Tech Service Tips

10

Summer 2009

Enhancements to Series
4180, 4182, 4280

1 Carburetor Enhancements

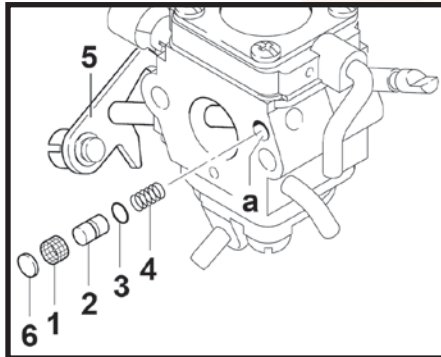
Advantages of the enhanced carburetors are a modified accelerator pump (2), choke shaft, throttle lever shaft and improved welch plug sealant. For improved sealing against dirt, the previous strainer in the accelerator pump cylinder bore will be replaced by a new sealing cap (6).

To improve sealing of the choke shaft and the throttle lever shaft (A), the shaft seals of the carburetor housings are changed. A modified seal with a sealing ring (B) and washer (C) can identify the new throttle shaft lever. Reference the corresponding STIHL Technical Bulletin for additional information.

2 Further Improvements

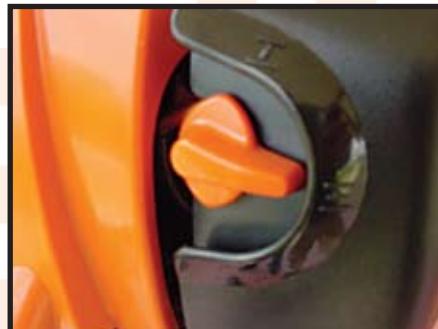
The choke knob, air filter cover, air filter housing, and carburetor spacer flange have also been optimized to increase durability and performance.

The new choke knob (B) has a larger grip area but can only be installed on the new carburetor version and can only be combined with the new filter cover (2). The previous version (A) remains available for older filter cover (1).

3 Cosmetic Upgrade

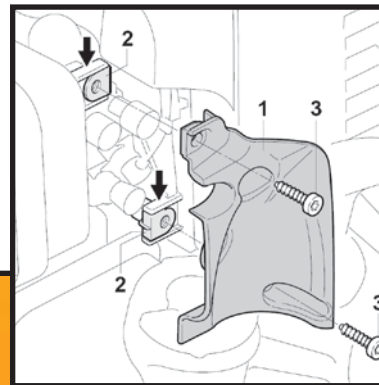
A new cover is installed between the filter housing and spacer flange. The filter cover has been changed to allow for the new design. More information regarding these changes can be referenced in STIHL Technical Bulletins 43.2008 and 44.2008.

The new cover (1) 4180 123 0600 will use push nuts (2) 9286 929 0030 to pan head self-tapping screws (3) 9074 478 3025 for fastening the cover to the mounts (arrows) on the filter housing and spacer flange.
